Beechcraft SERVICE BULLETIN

No. 64-3

SUBJECT: CHECKING THE STABILATOR FOR PLAY

AIRCRAFT AFFECTED: 23 (M-1 thru M-119).

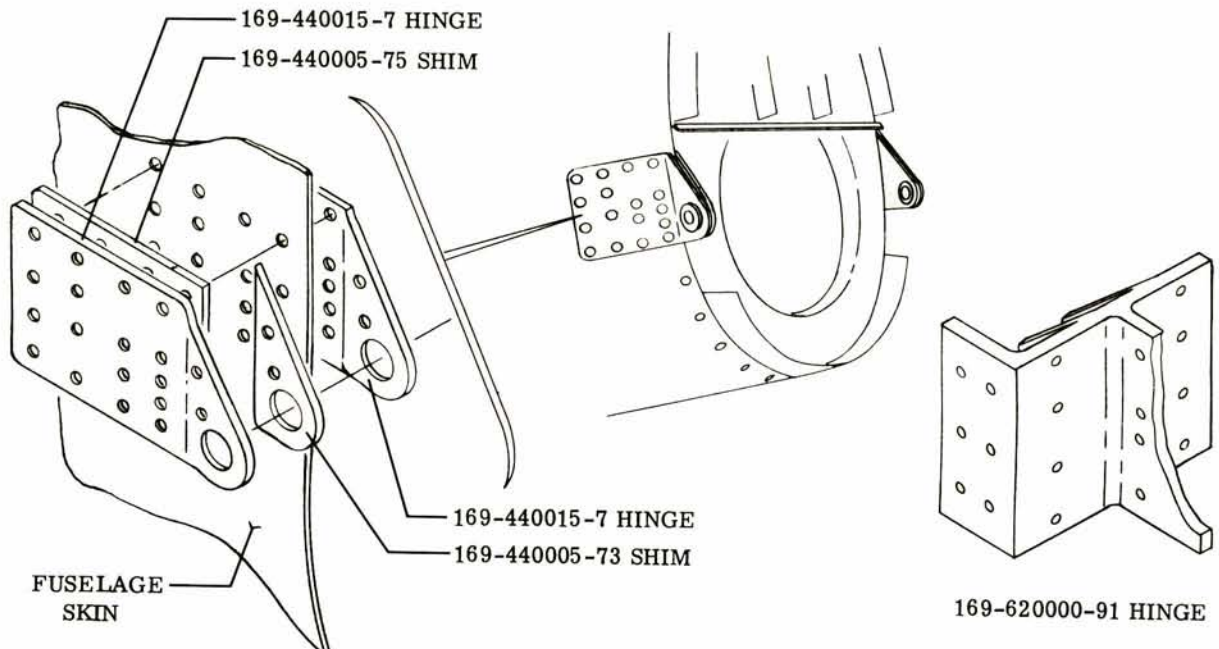
DESCRIPTION OF CHANGE: On all Musketeers with serials of M-120 and after, improved bearings were installed at the stabilator hinge points and the hinges on the fuselage tail section were strengthened by the addition of heavier hinges with support shims. Heavier extrusions were also installed on the stabilator to lessen the possibility of the bushings enlarging the holes in the extrusion at the hinging point of the stabilator.

Early Musketeers (serials M-1 thru M-119) should be checked for the extent of play at the stabilator tips. Excessive play is an indication of worn bearings or extrusions. If such play is in evidence, the stabilator should then be removed from the airplane, and the distance between the outside diameter of the bolt and the

inside diameter of the tail section bearings should be measured with a micrometer. If this distance exceeds .004 inch, the hinges can be modified in one of two different ways. One method of repair is to replace the existing bushings in the stabilator hinge with oversized bushings. The use of oversized bushings to reduce play is possible only if the diameter of the bushing hole in the existing hinge has not worn to a dimension greater than .4050 inch. Another method of repair is to bring the aircraft up to the configuration of current production models by the addition of heavier hinges.

c. Rivet the hinges and shim to the tail section with MS20470AD5-8 rivets as shown in the illustration.

d. Using a size 30 drill and taking care to observe the spacing and edge distances as established by standard aircraft repair practices, drill two holes in the hinges and in the 169-440005-73 shim at approximately the location shown in the illustration. Countersink the holes in each hinge so that the attaching rivets will be flush upon installation.

spar with a size 21 drill to match the rivet pattern of the hinge shown in the illustration, taking care to observe the spacing and edge distances as established by standard aircraft repair practices. It should be noted that the row of rivets that fitted into the pilot holes adjacent to each slot is omitted in the installation of the heavier hinges.
